**ADDENDUM No. 1**

**Lincoln and Adams Elementary Schools 2024 Kitchen Upgrades**

Arch. Project #220117

## ADDENDUM NO. 1

1 MAIN LEVEL MECHANICAL PLAN  
1/8" = 1'-0"

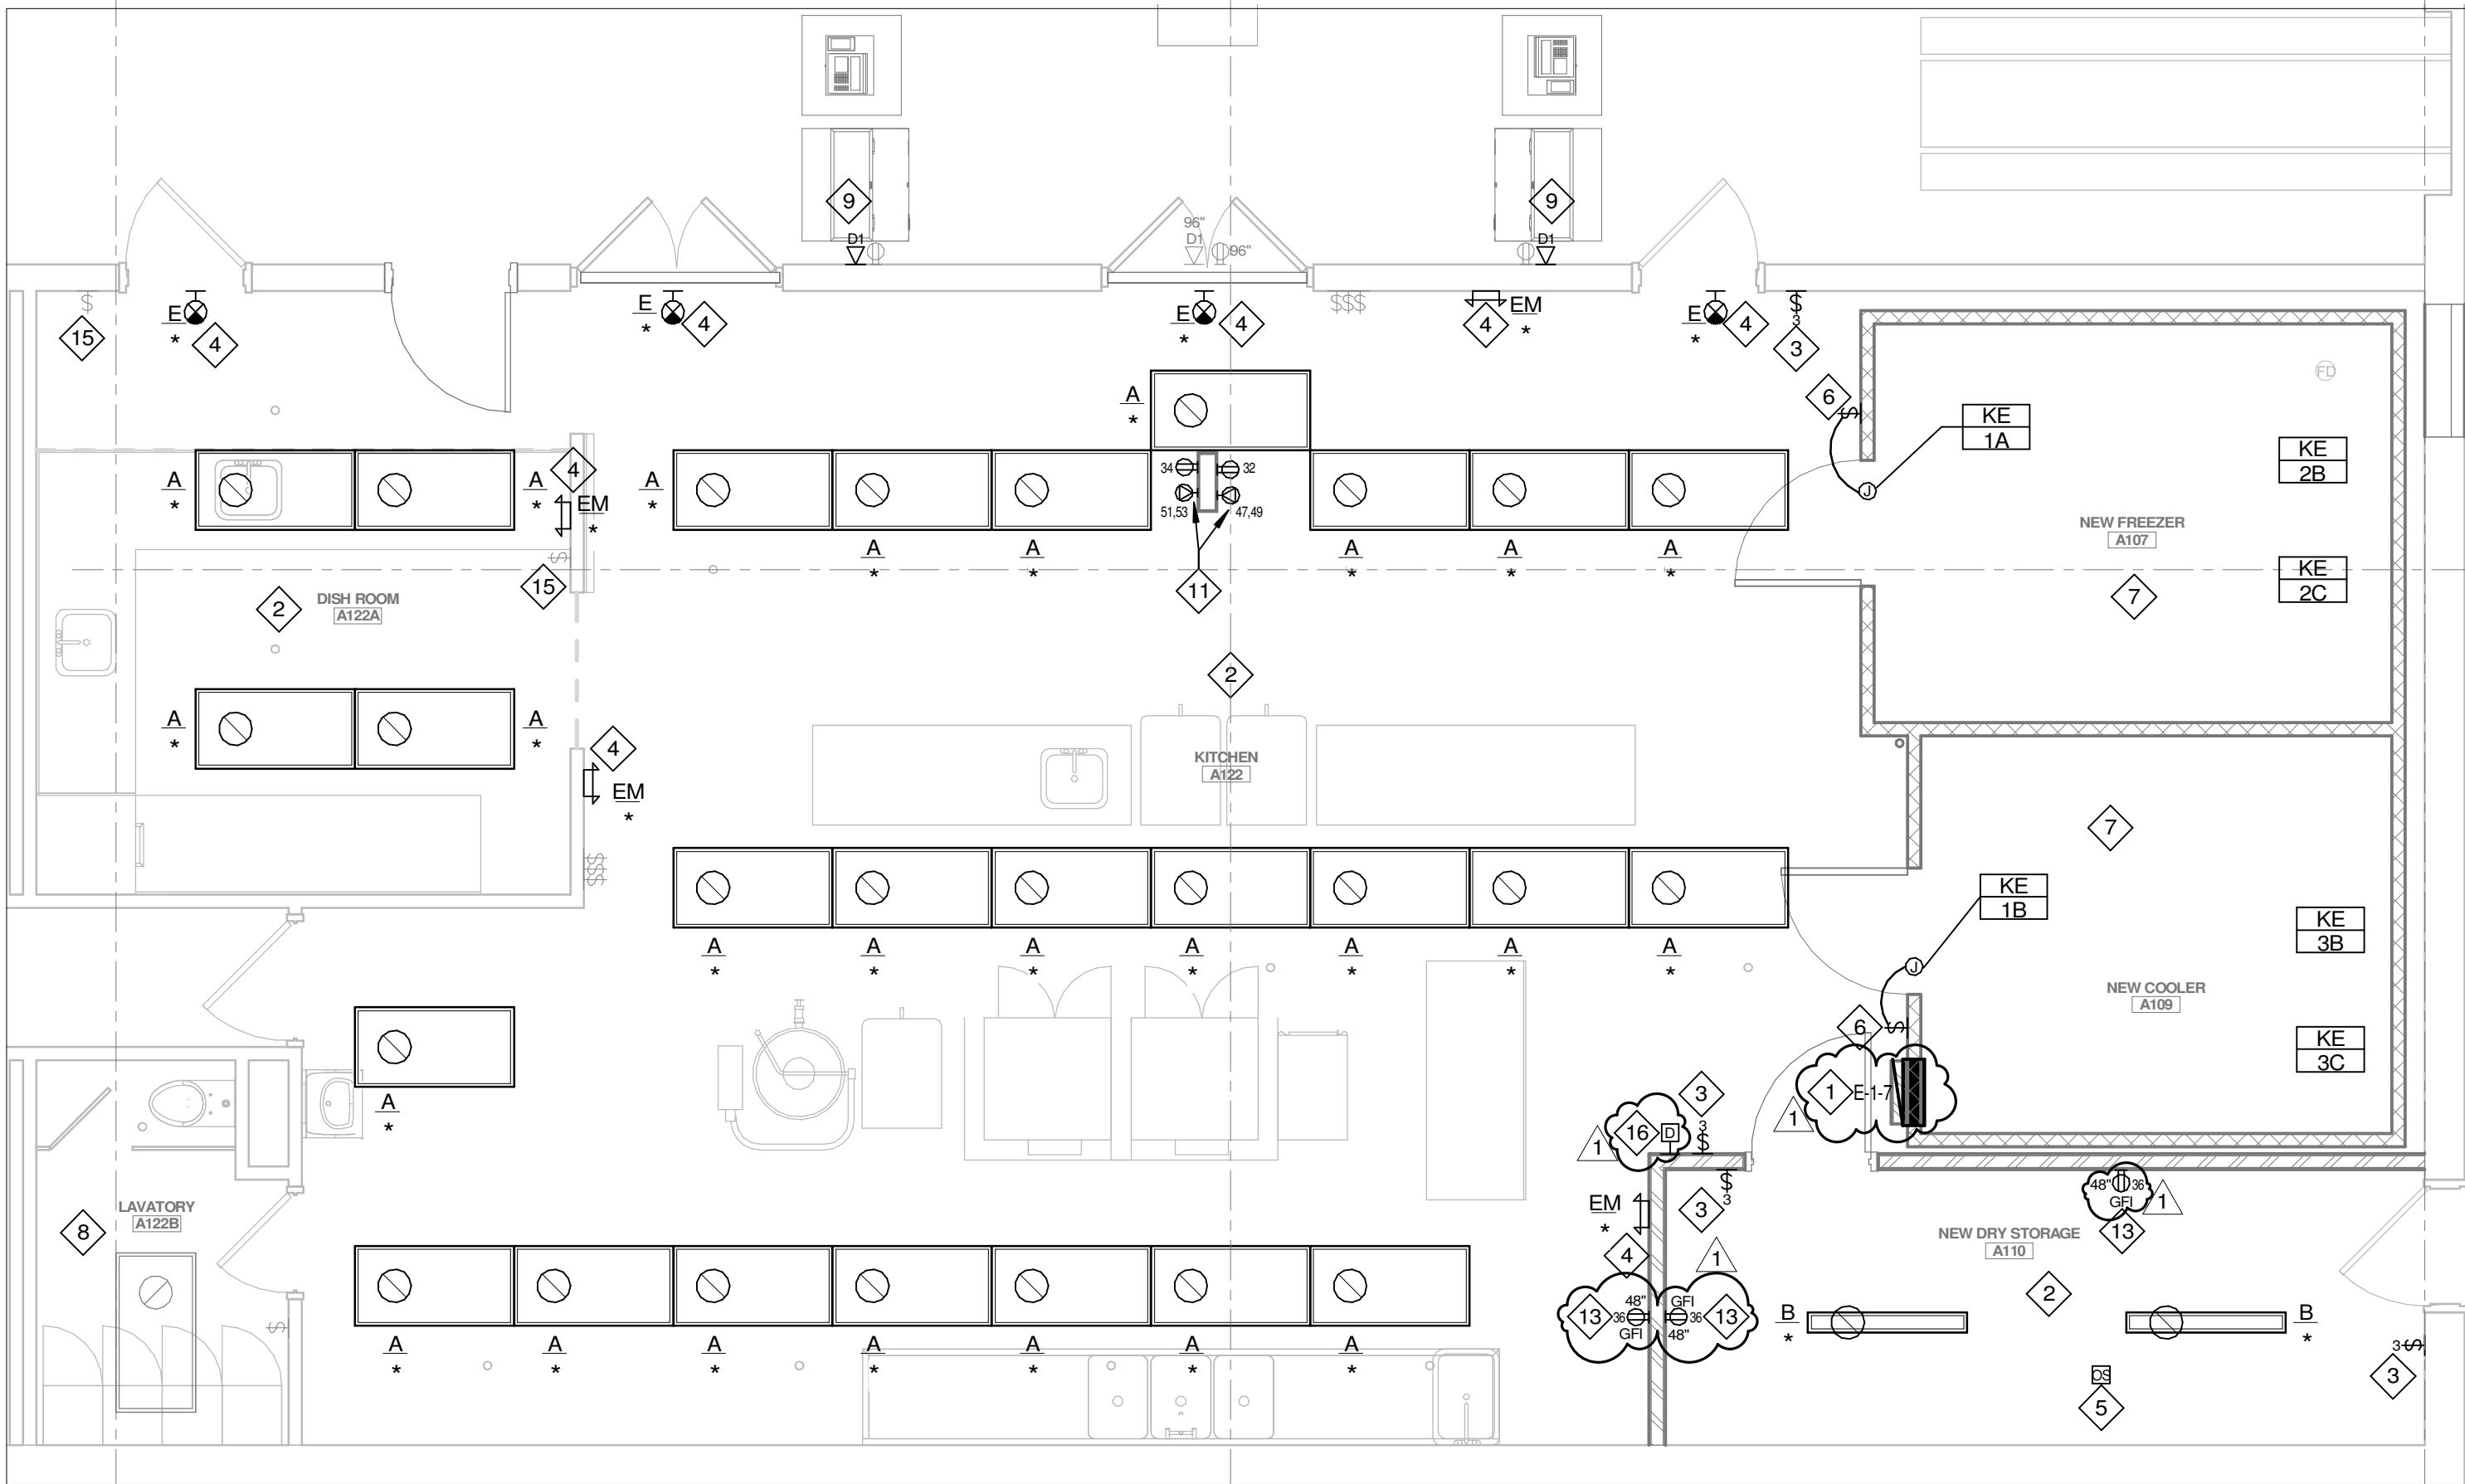
A. Refer to attached plan for revisions.

#### **1. E2.2 ADAMS ELECTRICAL PLAN**

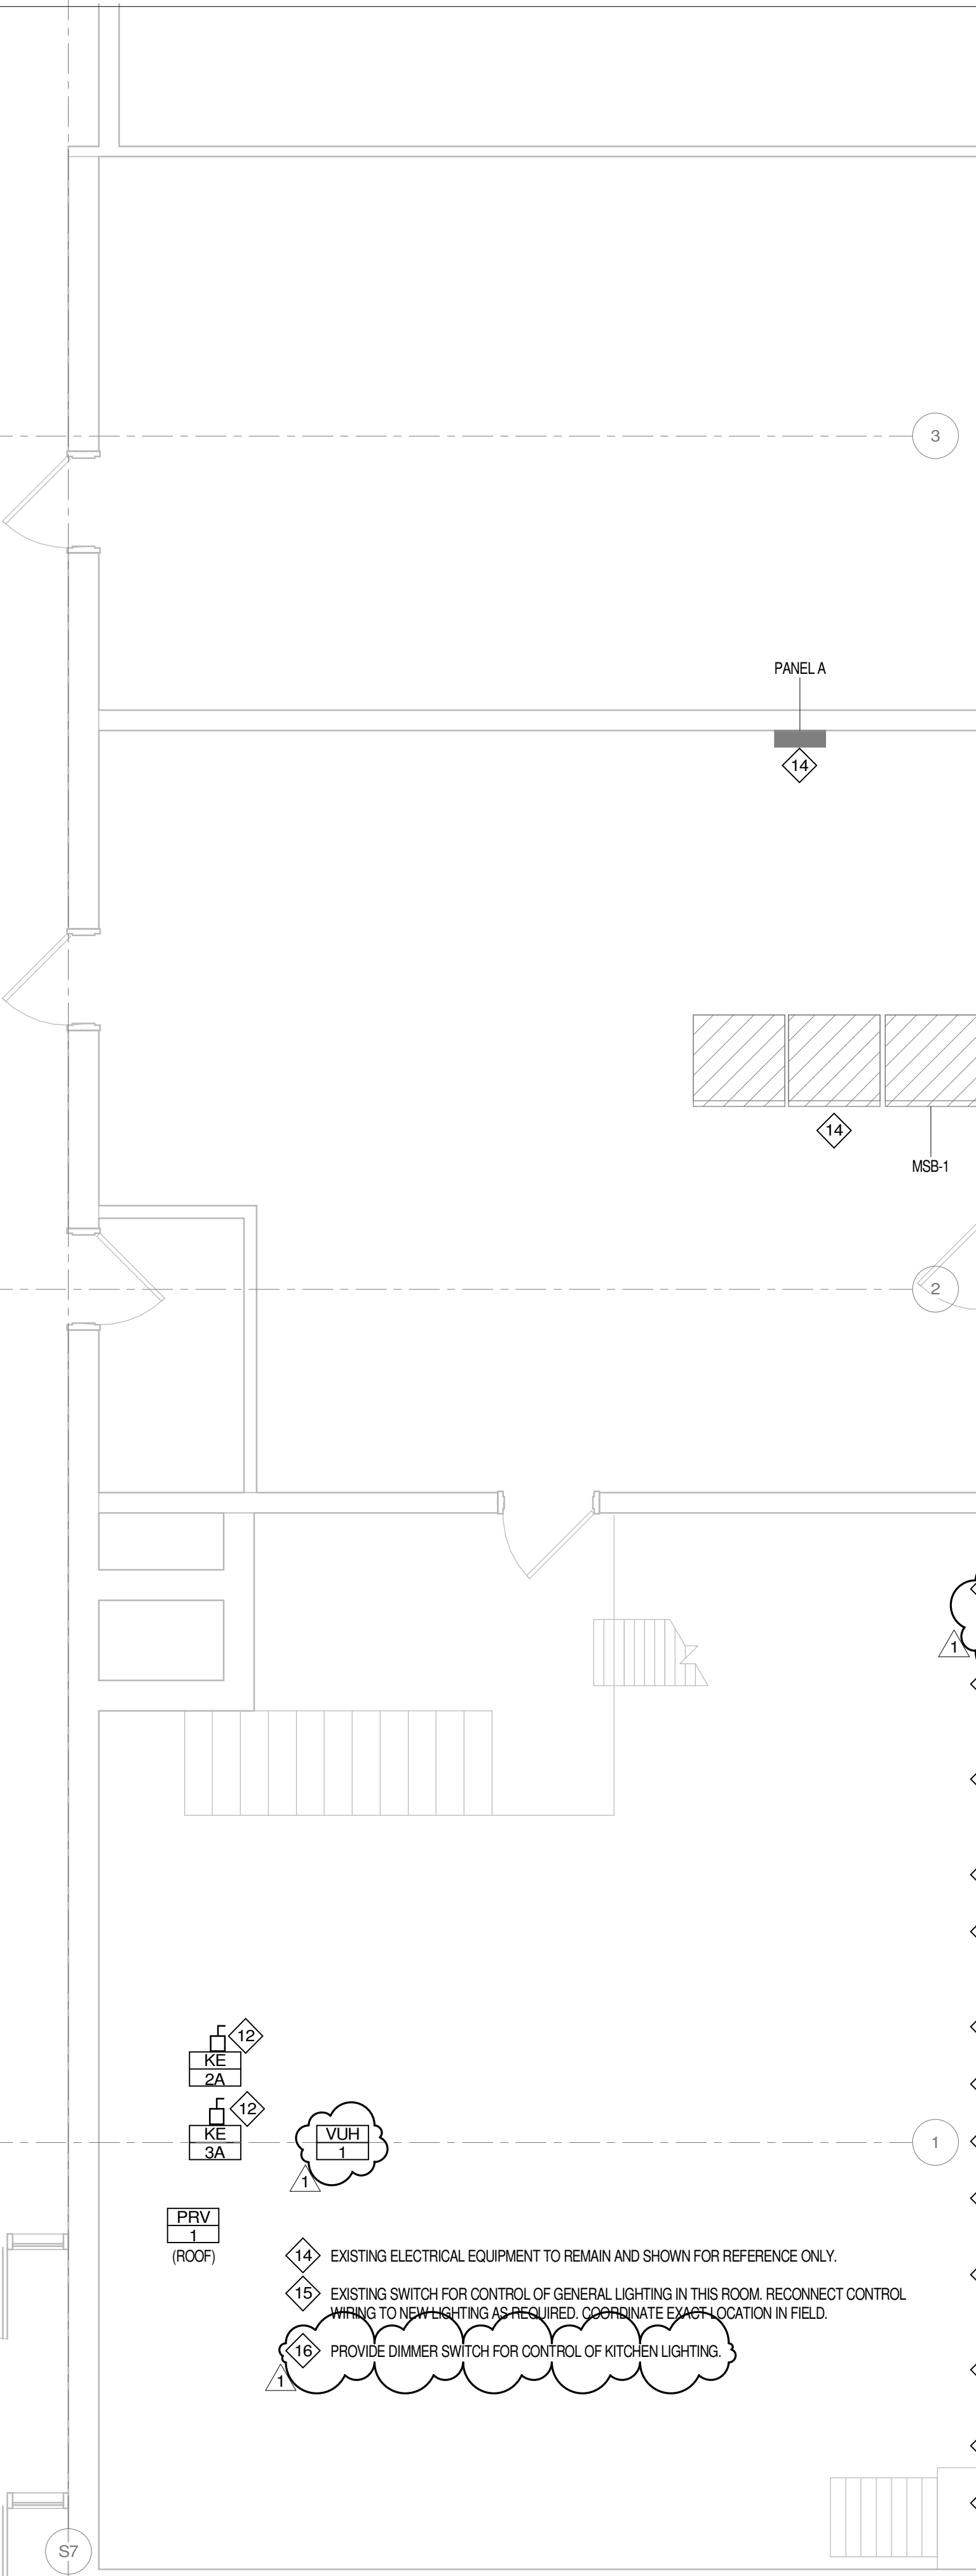
A. Refer to the attached plan for revisions.

E2.3

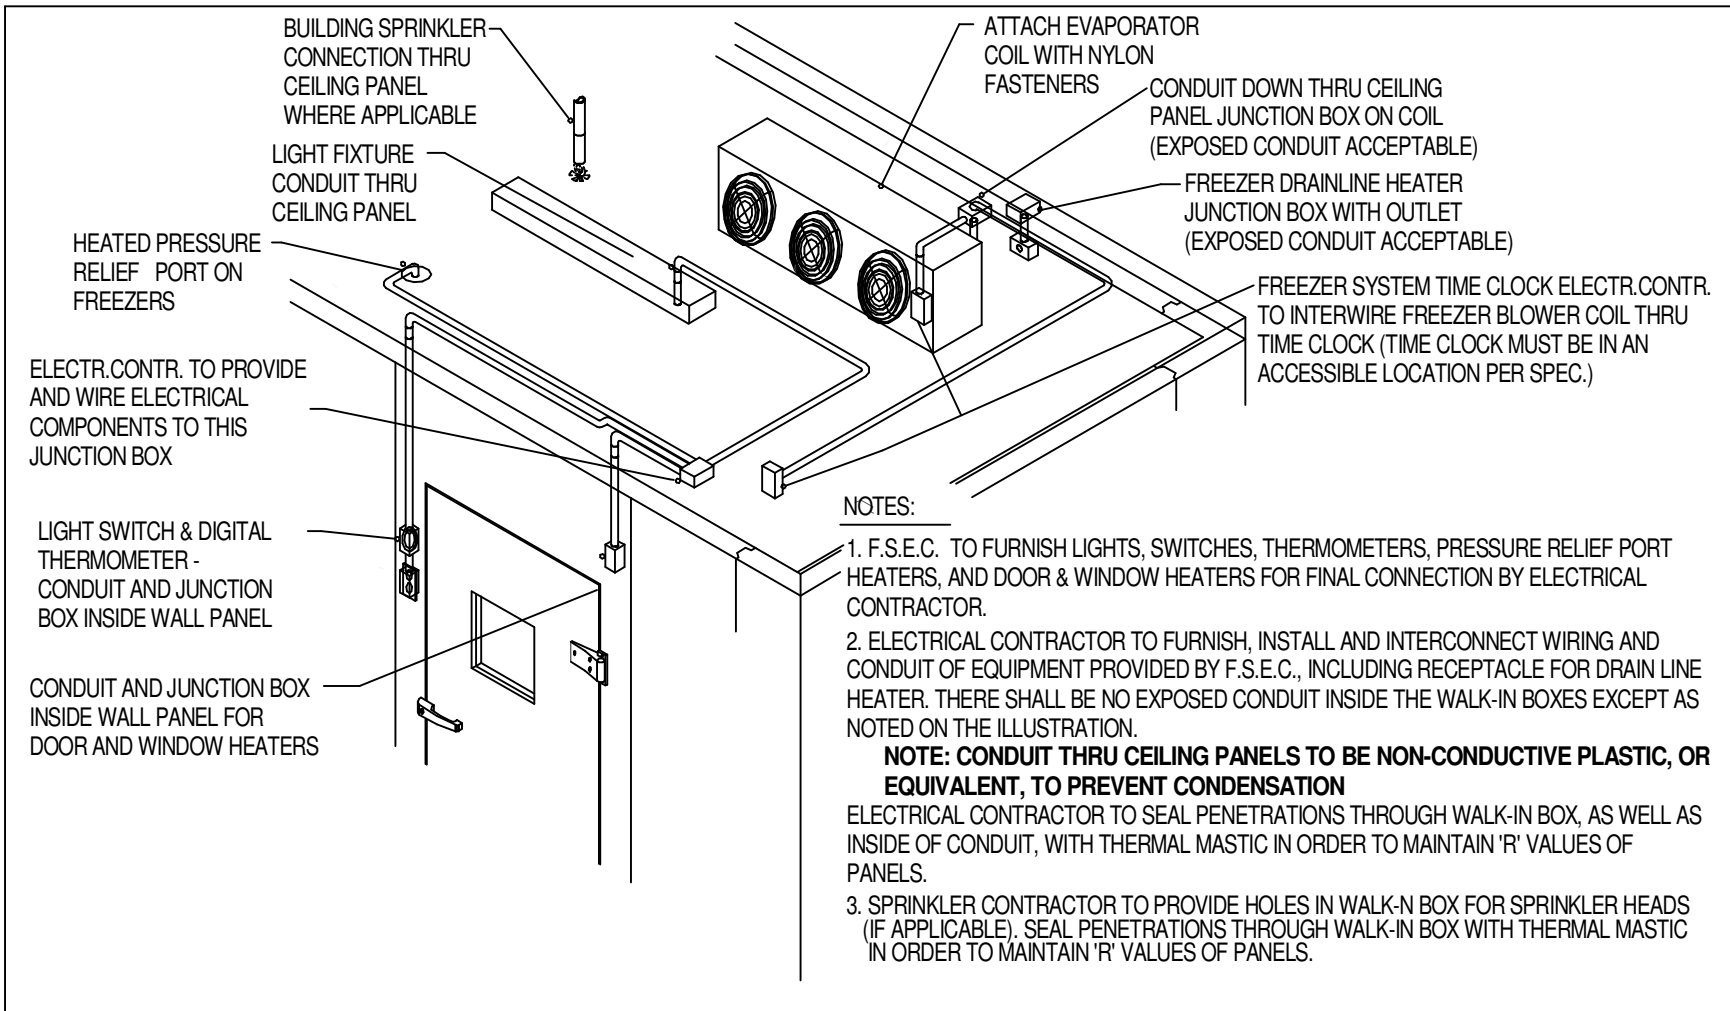
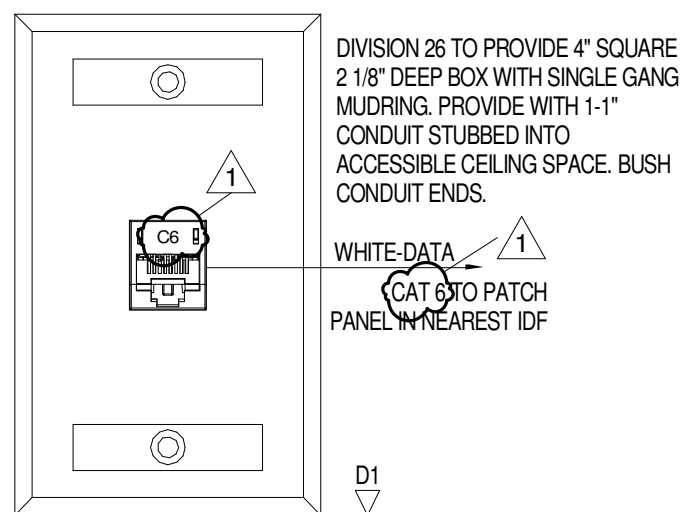
#### **2. E2.3 ADAMS ELECTRICAL SCHEDULES AND DETAILS**

A. Refer to the attached plan for revisions.
